Project	IEEE 802.16 Broadband Wireless Access Working Group < http://ieee802.org/16 >	
Title	Clarification of H-ARQ Operation with Reduced AAS Private Map	
Date Submitted	2005-01-20	
Source(s)	Inseok Hwang ,Jaehee Cho, Seungjoo Maeng, Jaeho Jeon, Soonyoung Yoon, Samsung Electronics Co. Ltd. Dave Pechner, Doug Dahlby, Todd Chauvin ArrayComm Inc.	is91.hwang@samsung.com dpechner@arraycomm.com
Re:	Recirculation of P802.16 REVe/D5a	
Abstract	Some clarification and modification of Reduced AAS private map is proposed for reliable H-ARQ operation.	
Purpose	Adoption of suggested changes into P802.16e/D6	
Notice	This document has been prepared to assist IEEE 802.16. It is offered as a basis for discussion and is not binding on the contributing individual(s) or organization(s). The material in this document is subject to change in form and content after further study. The contributor(s) reserve(s) the right to add, amend or withdraw material contained herein.

Fig. 1. Reduced AAS Private MAP Operation

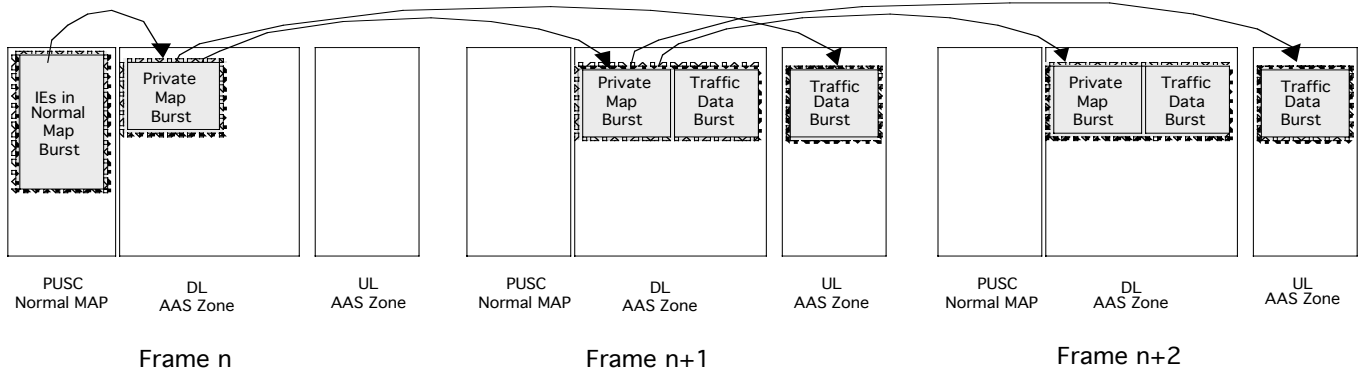
Fig. 1 illustrates the reduced AAS Private MAP operation when reduced AAS Private MAP points the allocation region for next frame. In the figure, dashed box denotes the absolute allocation region and (n+1)th frame.

To enable separate modulation and coding, the following fields are added in Reduced_AAS_Private_DL_MAP message. Note that when ‘Separate MCS Enabled’, DL data burst a reduced_AAS_Private_MAP including all AAS configuration change information, bandwidth allocation, H-ARQ signaling information are encoded separately.

- ‘Separate MCS Enabled’ to indicate separate coding for reduced AAS Private Map and DL data burst
- ‘Slot Duration’ to specify number of slots for transmitting reduced AAS_Private_MAP
- ‘DIUC and Repetition Coding Indication’ for reduced AAS_Private_MAP

Since the reduced AAS_Private_DL_MAP specifies the two-dimensional region for reduced AAS_Private_MAP and DL data burst, the data burst are transmitted through the remaining slots after assigning slots for reduced AAS_Private_MAP.
